**CITY OF MCMINNVILLE
PLANNING DEPARTMENT**
231 NE FIFTH STREET
MCMINNVILLE, OR 97128

DECISION, CONDITIONS, FINDINGS OF FACT AND CONCLUSIONARY FINDINGS FOR THE APPROVAL OF THREE MILE LANE DEVELOPMENT REVIEW FOR THE ADDITION OF A SECOND DRIVE-THRU SERVICE LANE AND ASSOCIATED SIGNAGE AT 225 NE NORTON LANE.

- DOCKET:** TML 2-20 (Three Mile Lane Development Review)
- REQUEST:** Application for Three Mile Lane Development Review to allow for the construction of a second drive-through service lane and associated signage at a McDonald's restaurant within the Three Mile Lane Planned Development Overlay District.

Figure 3: Applicant's Proposed Site Plan

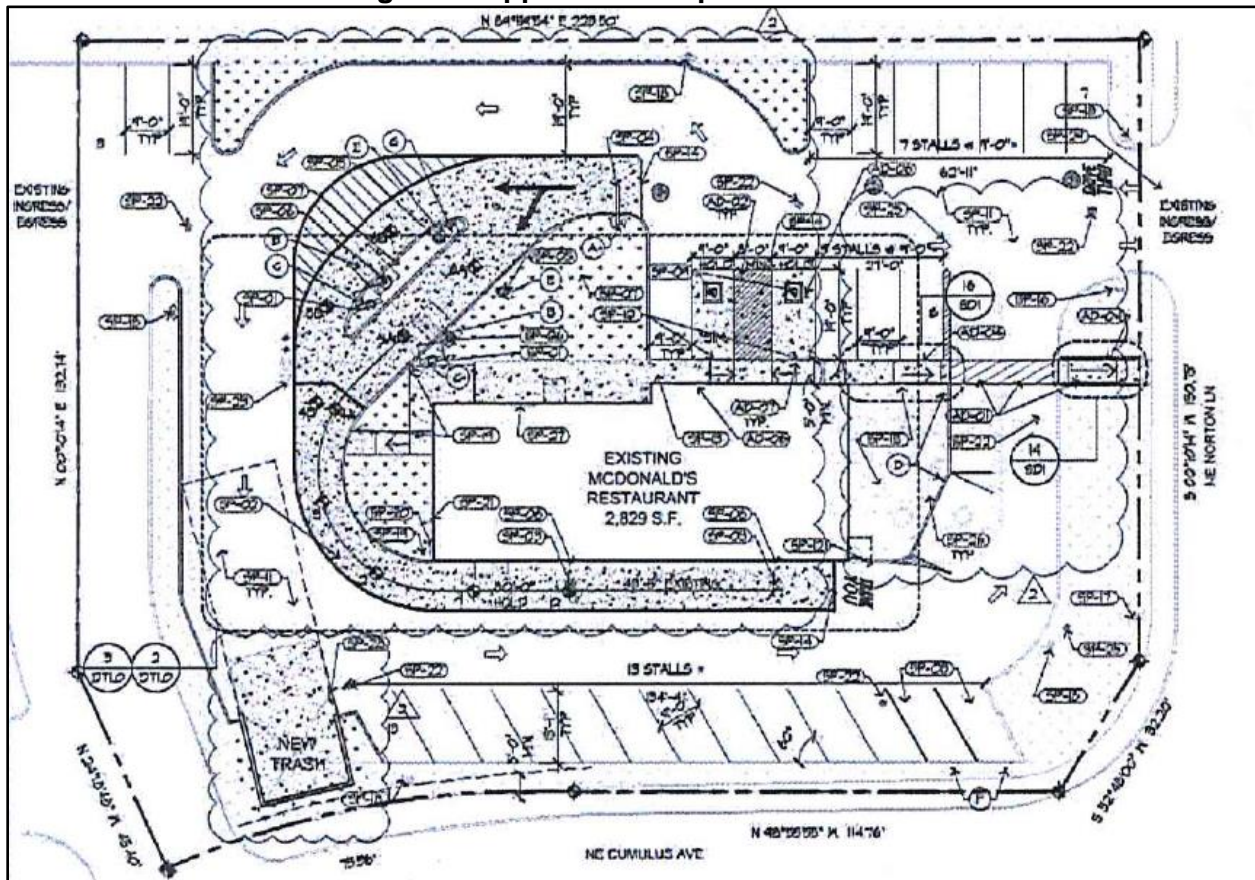
The proposed site design efficiently incorporates the two drive-up service lanes into the existing driveway and parking aisles. To accommodate this, surplus parking was removed, additional landscape area was included, and the trash and recycling enclosure was relocated. Parking requirements and trash enclosure standards continue to be met as described in findings for those sections of the McMinnville Zoning Ordinance described above.

Figure 4: Applicant's Proposed Signage Plans

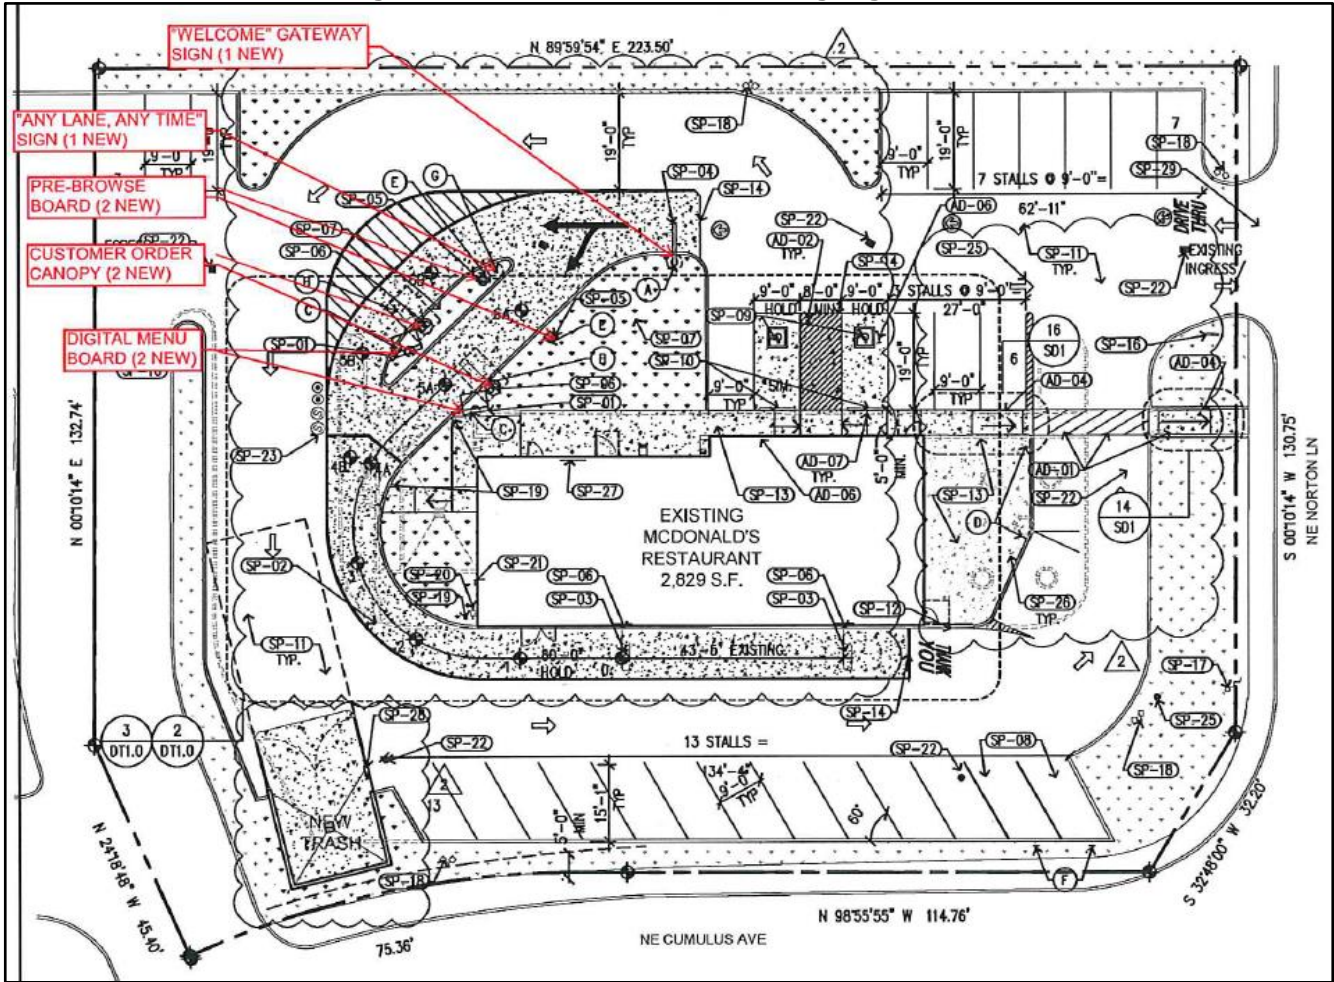
FINDING: SATISFIED WITH CONDITIONS OF APPROVAL #1 AND #2. The proposed re-development of the site includes eight (8) signs associated with the two (2) drive-thru service lanes: one (1) "Welcome" Gateway Sign, one (1) "Any Lane, Any Time" Directional Sign, two (2) Pre-Browse Boards (one per lane), two (2) Customer Order Canopies (one per lane), and two (2) Digital Menu Boards (one per lane). Staff notes that the property shares a free-standing sign with the adjacent property, which exhausts the allowance for free-standing signs listed in subsection (B)(1)(a) above for the subject site. Therefore, proposed signage must comply with subsection (B)(7) or be deemed incidental directional signage per subsection (B)(3). Subsection (B)(7) is proposed by the applicant in a concurrent application to be included in the Three Mile Lane Planned Development Ordinance. Therefore, a condition of approval is included to require the adoption of Zoning Text Amendment (ZC 2-20) prior to the approval of the Three Mile Lane Development Review for the subject property.

The proposed Digital Menu Boards are less than six (6) feet in height with surface areas of approximately 20 square feet. These dimensions are less than the maximum height and area dimensions for the first additional freestanding sign allowed per order station. One (1) sign meeting these standards is permitted for each drive-up order station.

The proposed Digital Pre-Browse Boards are approximately six (6) feet in height with surface areas of approximately 10 square feet. While the area of the Pre-Browse Boards is below the maximum allowed, the proposed height of approximately six (6) feet exceeds the maximum height of five (5) feet for secondary signs allowed per order station. Therefore, a condition of approval is included to require that the Digital Pre-Browse Boards be a maximum of five (5) feet in height. One (1) sign meeting these standards is permitted for each drive-up order station.

CONDITIONS FOR FINDING: That the decision for approval of Three Mile Lane Development Review (TML 2-20) is not rendered, and does not take effect, until and unless the Zoning Text Amendment request (ZC 2-20) is approved by the City Council.

That the two (2) Digital Pre-Browse Boards shall not exceed five (5) feet in height.
